GREATER GEELONG PLANNING SCHEME

Proposed C433ggee

SCHEDULE 57 TO CLAUSE 43.02 DESIGN AND DEVELOPMENT OVERLAY

PAKINGTON NORTH PRECINCT

Figure 8. Open space interface

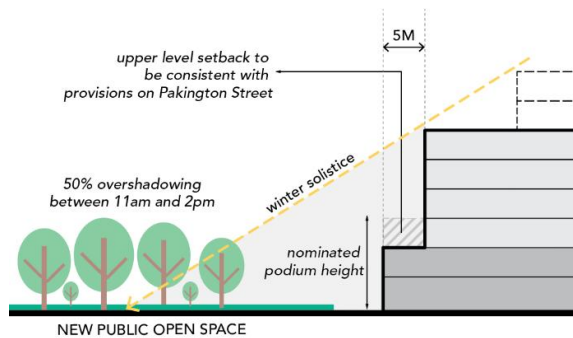
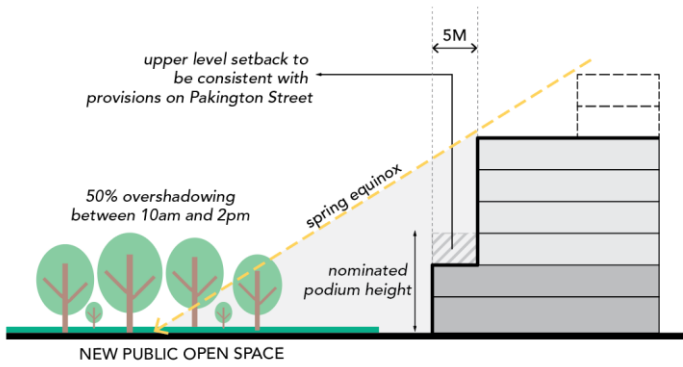
Commented [G13]: Response to JG rec 1 as per his Appendix D

Commented [COGG14]: Response to JG rec 10 (part) and ref. AR rec. 50 (in part).

[Editing Note: Delete diagram above and replace with diagram below showing label spring equinox and 10am-2pm.]

Commented [G15]: Implements Council officer response to Submitter 35 (per 25.11.2025 Council resolution)

Editing Note: Edit diagram below to refine building envelope to be more generic, label as max 50% and edit spring equinox line to correct angle.

Commented [COGG16]: Ref JG rec 11 (part) and AR rec 20 (part).

Map 1 to Schedule 57 to Clause 43.02

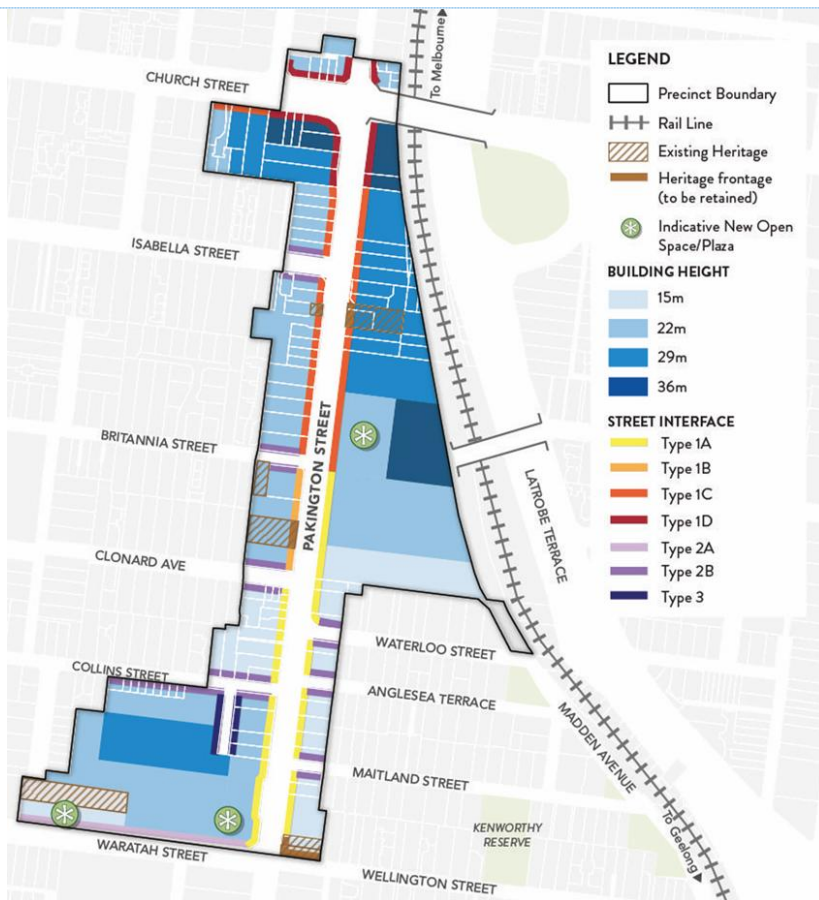
[Editing Note: Delete information re. Railway Sidings site]

[Editing Note: Remove indicative open space icon from SE corner of Pakington Strand site]

[Editing Note: Add Type 2C and 2D to key – to correspond with Revised Table 2]

[Editing Note: Remove street interface designation from 2-8 Church Street]

[Editing Note: In the legend, amend 'Heritage frontage (to be retained)' to 'Heritage frontage (setback to heritage fabric to be retained)']

Commented [COGG53]: Response to JG rec 2 and Sophie Jordan (SJ) rec 1.

Commented [COGG54]: Responds to SJ rec. 56.

Commented [COGG55]: Response to Panel question/comment.

Commented [COGG56]: Response to JG verbal evidence. Site does not require a specified setback.

Commented [COGG57]: Response to Panel query/comment about how mandatory ground level setback requirements were to apply to heritage places.

Commented [COGG58]: Not considered necessary to show specific interface of Pakington Strand site with 1/2 Waratah Street as side boundary covered by Figures 9 and 10.

Map 2 to Schedule 57 to Clause 43.02

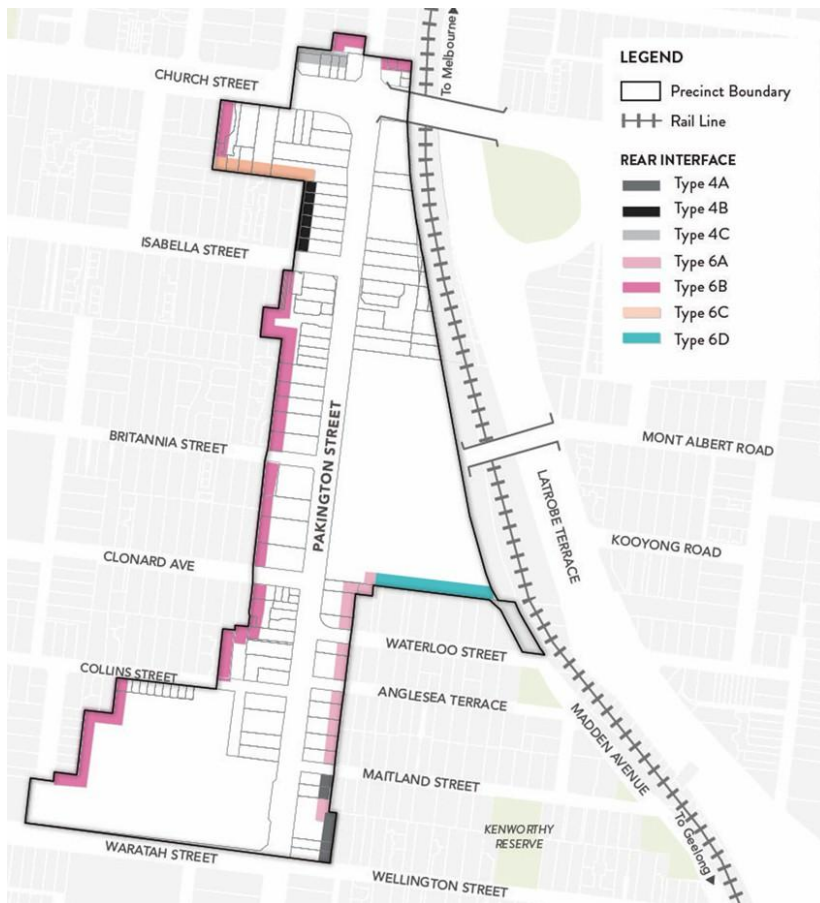
[Editing Note: Delete information re. Railway Sidings site]

[Editing Note: In the legend, amend 'Rear interface' to read 'Residential interface']

Commented [G59]: Responds to JG rec 2 and SJ rec 56

Commented [COGG60]: Response to Panel observation of inconsistency between terminology in legend and sub-heading within cl 2.0 of DDO57

Commented [G61]: Responds to JG rec 2 and SJ rec 56
